NORTHGATE TOWN SQUARE LANDSCAPE REVISIONS

PROJECT: NORTHGATE TOWN SQUARE
 ADDRESS: 1000 NORTHGATE DRIVE, SAN RAFAEL, CA 94903
 SUBJECT: LANDSCAPE REVISIONS
 DATE: JUNE 4, 2024

Please find below revisions per last issuance dated July 21, 2023.

OVERALL PLANTING PLAN - 2025 MASTER PLAN

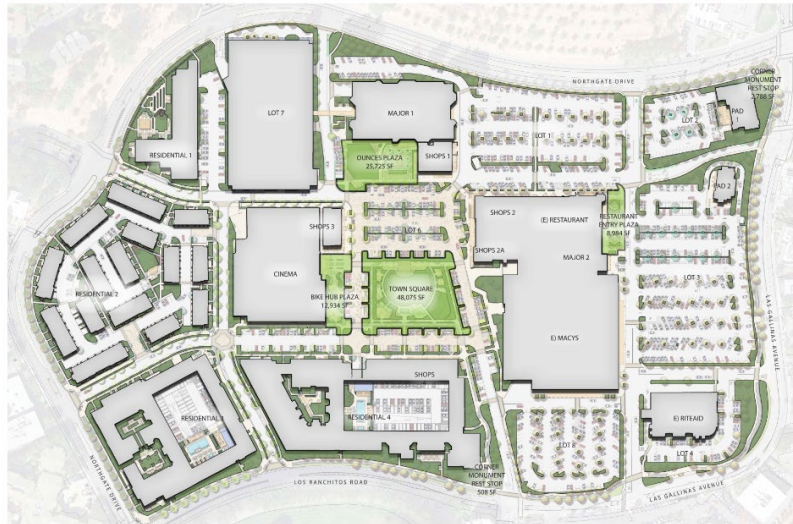
L-1 Overall Planting plan has been adjusted to include changes to Residential 1, the Town Square, the spill out at Major 1 (Ounces Plaza), bike rest stops at Merrydale entry to site and corner of Northgate drive and Las Gallinas, and loading at Major 2.

LANDSCAPE AREA DIAGRAM - 2025 MASTER PLAN

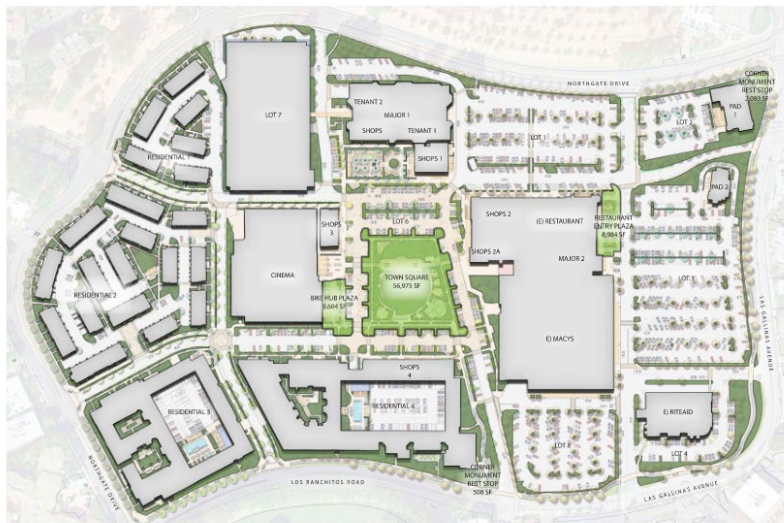
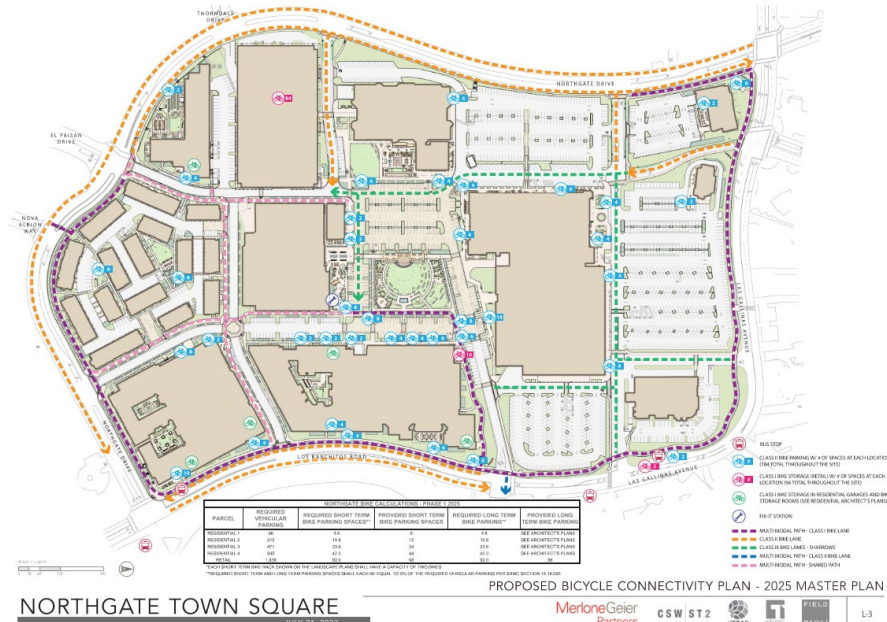
L-2 Landscape Area Diagram has been adjusted to reflect site plan changes. Calculations have been updated based on changes. The Town Square increased in size from 48,075 SF to 56,975 SF per DRB recommendations. Ounces plaza is no longer highlighted in green due to site plan changes.

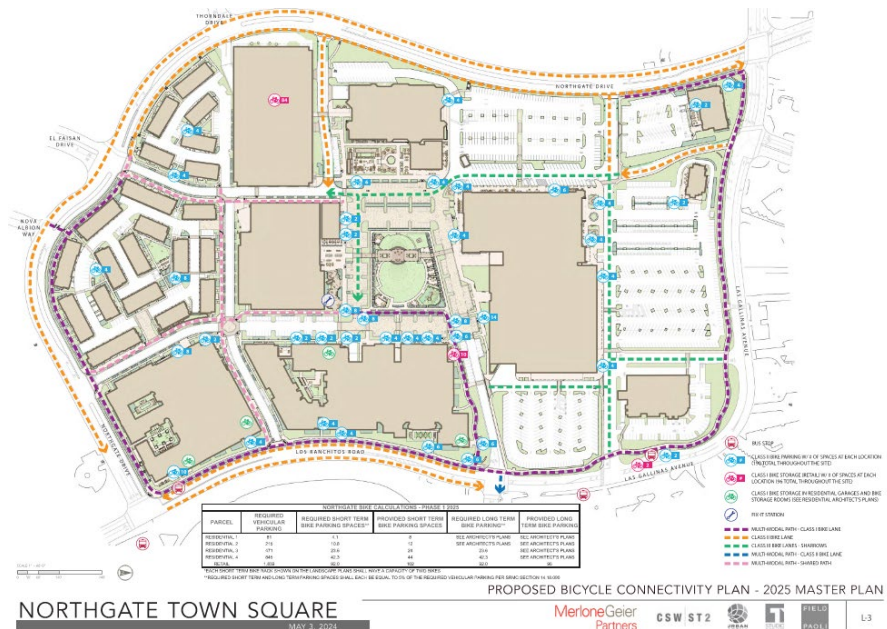
L-3,L-4 Proposed Bicycle Connectivity Plan and Pedestrian Connectivity Plans. Short term bike parking has been adjusted at Residential 1, bike rest stop at Merrydale entry to site, and bike rest stop. Bike Parking increased from 184 to 190. Pedestrian circulation has been adjusted to reflect site plan changes.

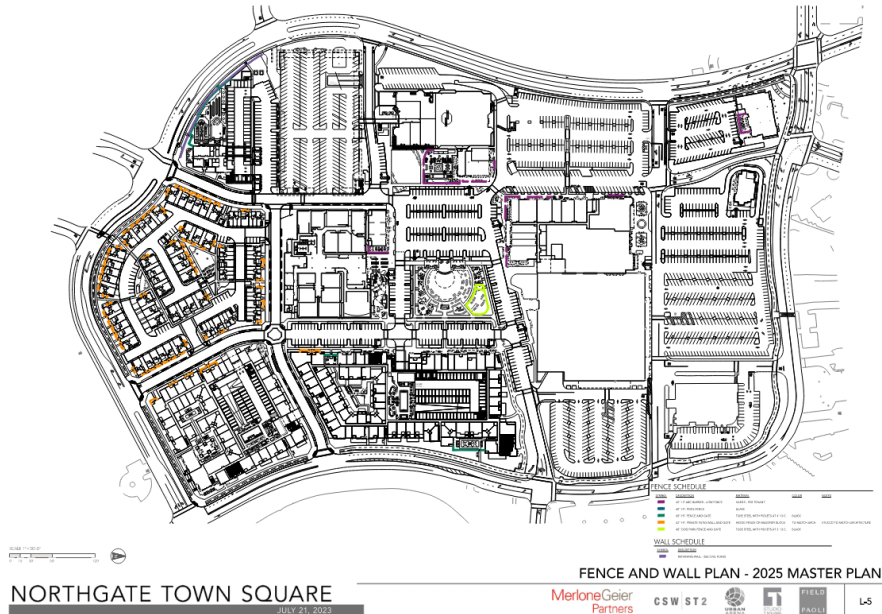
L-5 Fence and Wall Plan has been updated to reflect site plan changes at Residential 1, Town Square, and Ounces Plaza in front of existing Kohls.

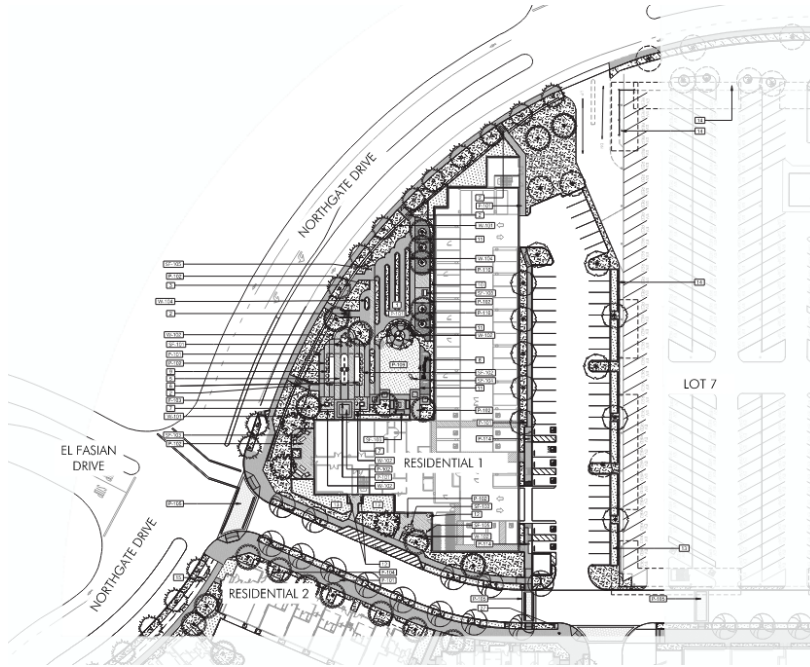
L-10 Residential 1 Enlargement plan and calculations have been updated to reflect the townhome plan.

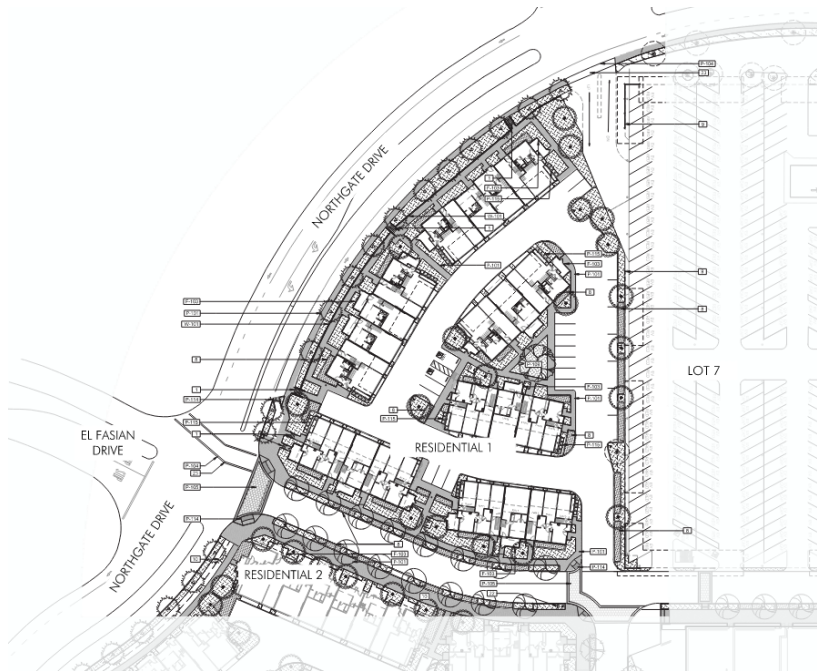
L-11 Residential 1 Detailed Enlargement has been updated with the townhome plan. Tree counts in conceptual planting legend have been updated.

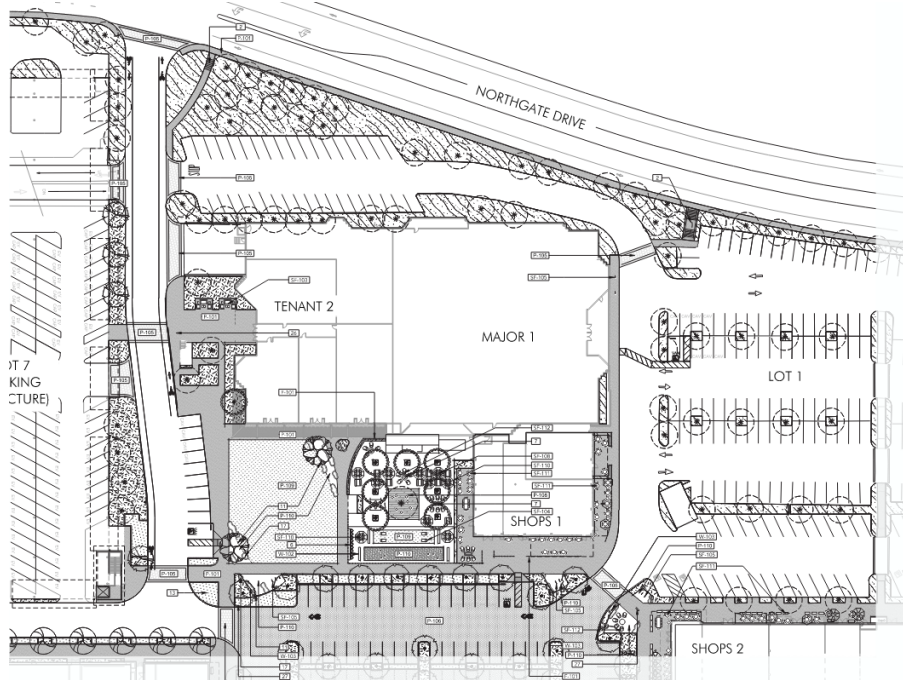
L-17 Major 1 Enlargement Plan has been updated to reflect the new ounces brewery layout. Retail spill out and a public entry plaza has been added to the plan.

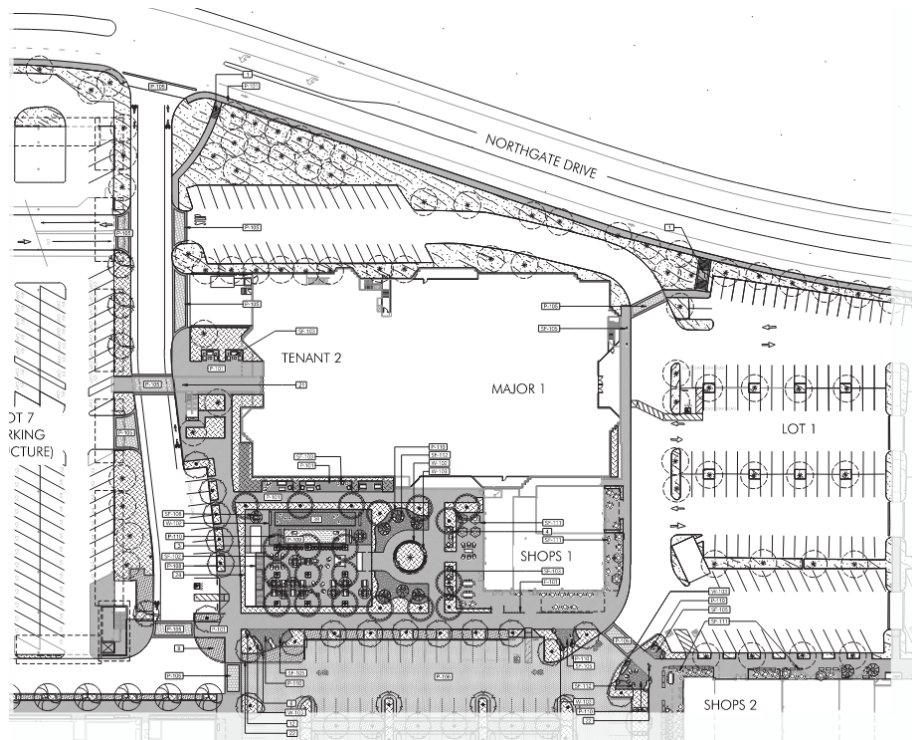
L-18 Major 1 Detailed Enlargement has been updated to include the changes described above.

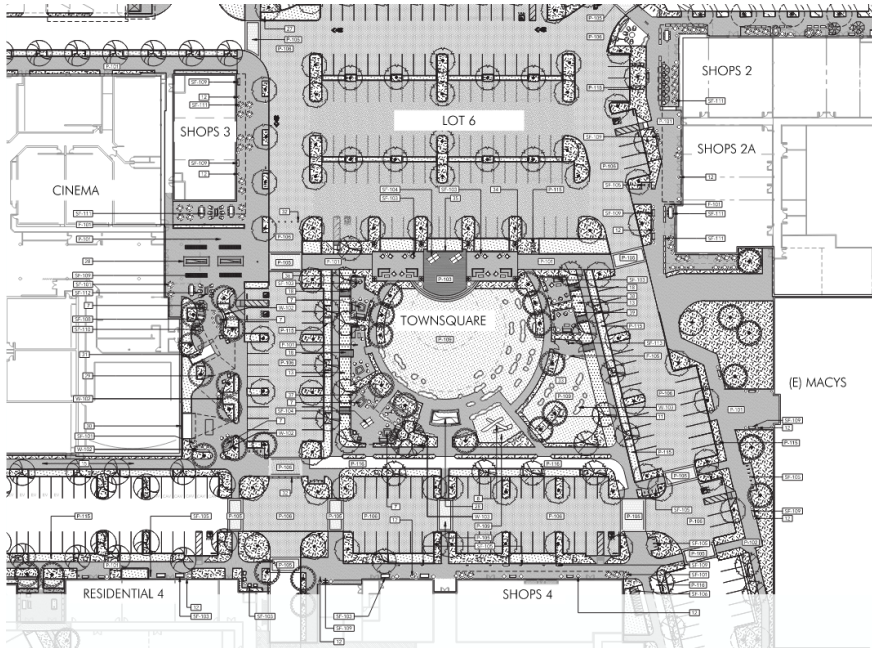
L-19 The Town Square Enlargement has been updated to reflect the larger Town Square. The site plan for the Town Square has been modified per DRB recommendations and community comments. The Town Square increased in size from 48,075 SF to 56,975 SF. The synthetic turf has been changed to natural turf. The faux boulders have been altered to be natural boulders and there are fewer boulders to make the lawn more open and usable. Trees have been added along the perimeter of the open turf space for shade, the Town Square spill out spaces have overhead cover, and the pavilion has additional seating to provide shade. The large space along the north part of the Town Square is used for a larger feature playground. The dog park has been moved to a smaller portion of the Town Square.

- Increase size of the town square
 - The Town Square increased in size from 48,075 SF to 56,975 SF.
- Eliminate the dog park and repurpose the area within the Town Square.

- The dog park has been moved to a smaller portion of the Town Square and the location that the dog park was in is now a larger feature playground.
- Eliminate synthetic turf or other faux natural features as part of the design of the town square and use natural products instead.

- The synthetic turf has been changed to natural turf. The natural turf area has increased within the Town Square. The faux boulders have been altered to be natural boulders and there are fewer boulders to make the lawn feel more open and usable.

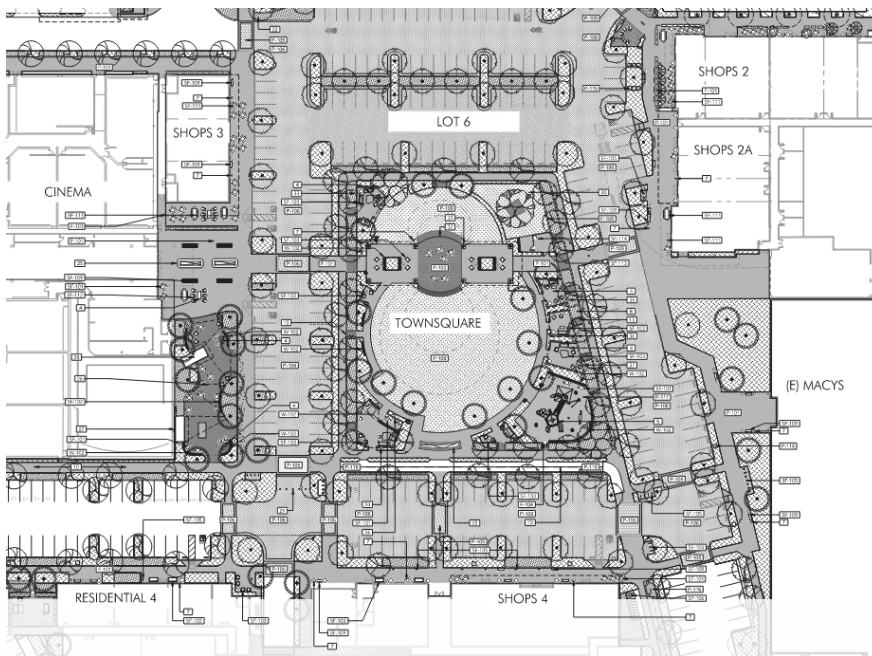
L-20 Town Square Detailed Enlargement has been updated to include changes described for L-19 above.

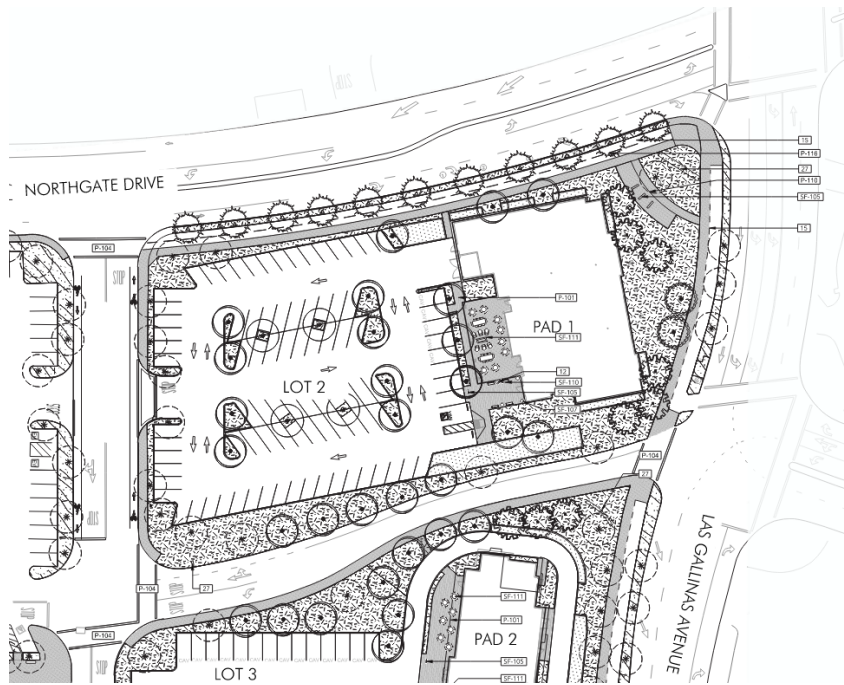
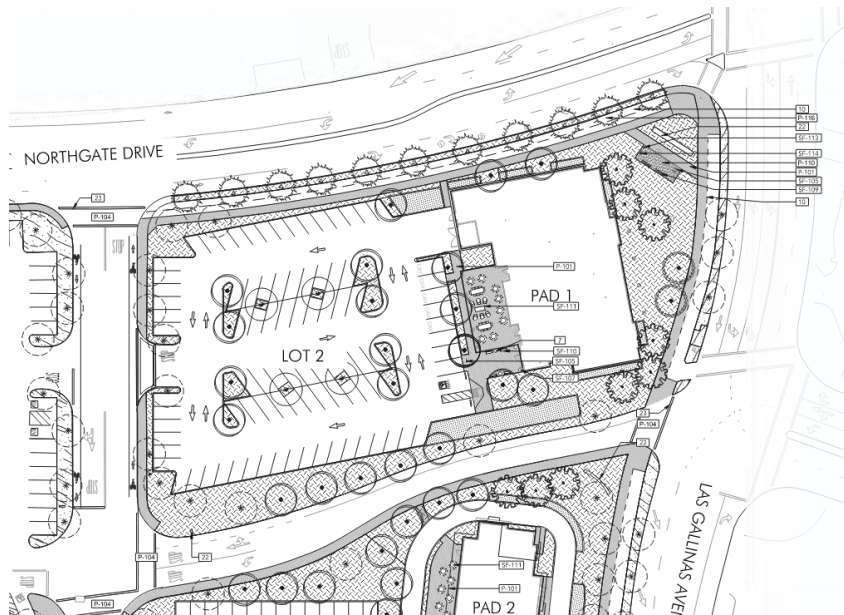
- L-25 Bike rest stop along corner of Northgate Drive and Las Gallinas has been adjusted with additional amenities. Amenities include a water fountain, benches, a dog waste dispenser, and bike racks.

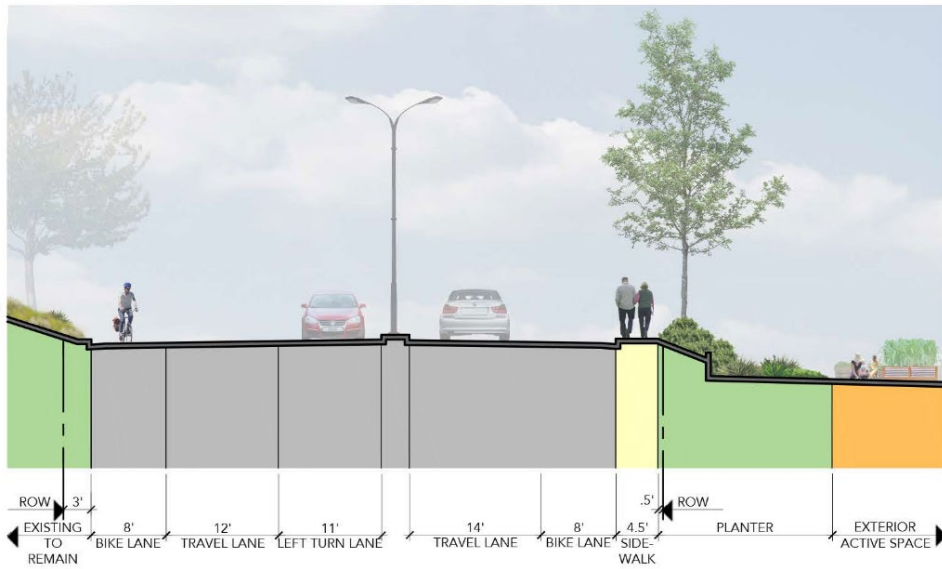
L-34 Section 9 has been updated to include the changes along the existing Cinema frontage.

SECTION 13

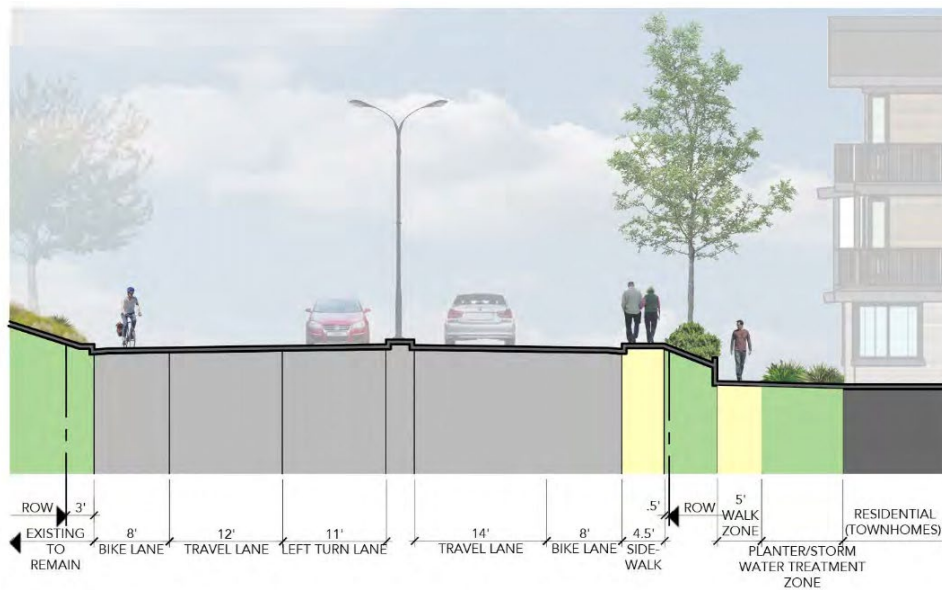
L-35 Section 13 has been updated to include the condition of the landscaping at the proposed Residential 1 townhomes.

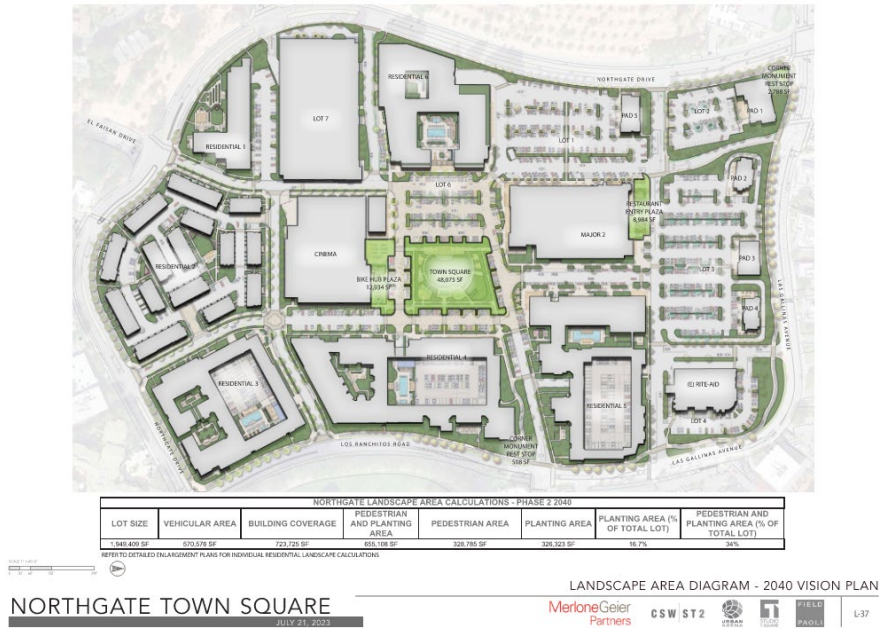
L- 36 Overall Planting plan has been adjusted to include all the changes to the 2025 plan and the changes to Residential 5 ground level landscape.

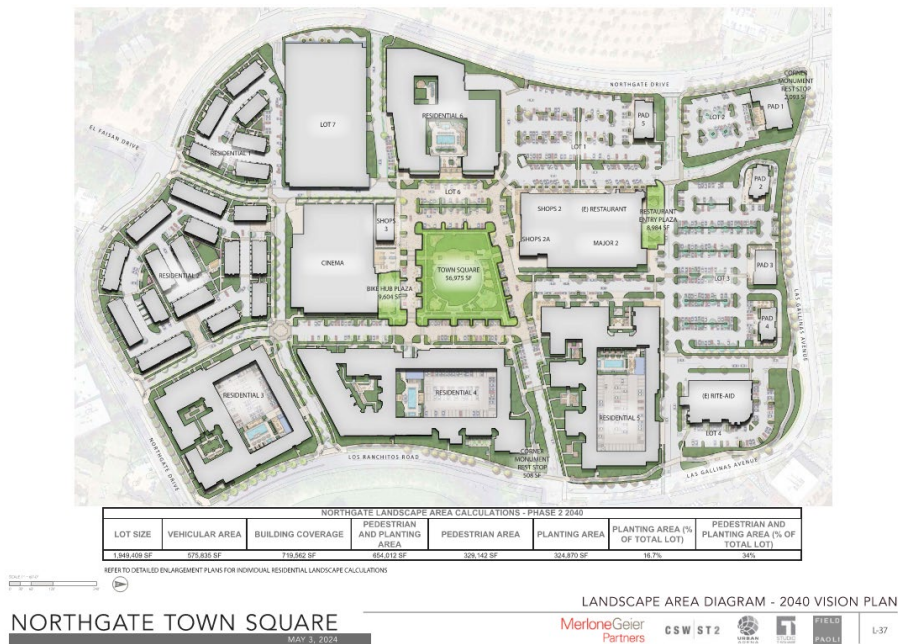
L-37 The Landscape Area Diagram has been adjusted to reflect site plan changes. Calculations have been updated based on changes. The Bike Hub from 2025 is now included in the 2040 plan.
